Subdivision Authority

File No. LDA07-0374

RE: Tentative plan of subdivision to create 17 industrial business lots from portions of SW-21-51-24-4, Lot 2; Block X; Plan 0226318 and Lot 1; Block 24; Plan 0729093 located east of 91 Street and north of 25 Avenue, **SUMMERSIDE**.

I The Subdivision by Plan is APPROVED on May 8, 2008 subject to the following conditions:

SUBDIVISION CONDITIONS OF APPROVAL MAP

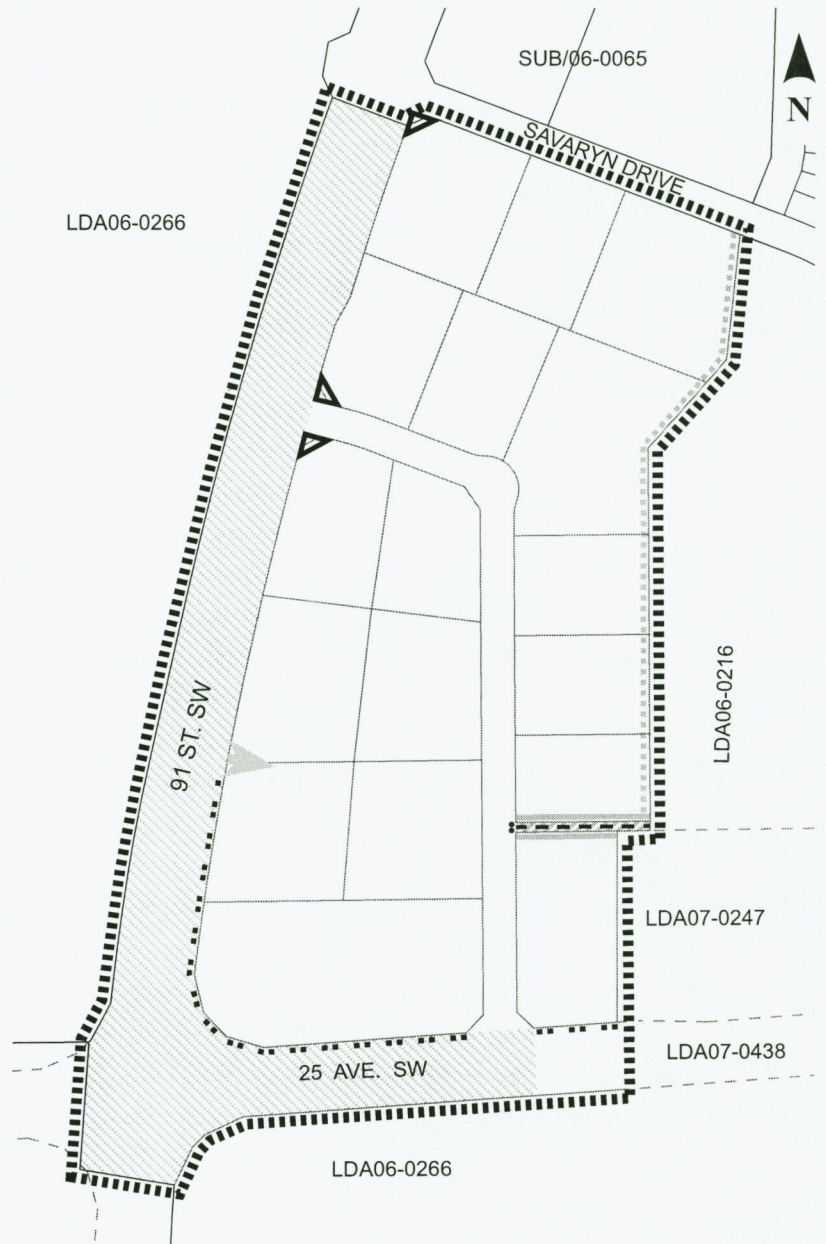
4. that the owner level and clear the 91 Street SW and 25 Avenue SW right-of-way dedications to the satisfaction of the Transportation Department;
5. that the owner register the 6 meter utility easement as road right-of-way, as shown on the "Conditions of Approval" map, Enclosure 1;

6. that the owner provide a 10 meter x 10 meter corner cut to the satisfaction of the Transportation Department as shown on the "Conditions of Approval" map, Enclosure 1;

7. that a joint access easement be registered in favour of the City of Edmonton as shown on the "Conditions of Approval" map, Enclosure 1; and
8. that the owner pay all outstanding property taxes prior to the endorsement of the plan of subdivision.

7. that the owner construct the 1.5 meter concrete sidewalk and lighting, bollards and all fences positioned wholly on privately-owned lands to the satisfaction of the Asset Management and Public Works and Transportation Departments in the location as shown on the "Condition of Approval" map, Enclosure 1; and
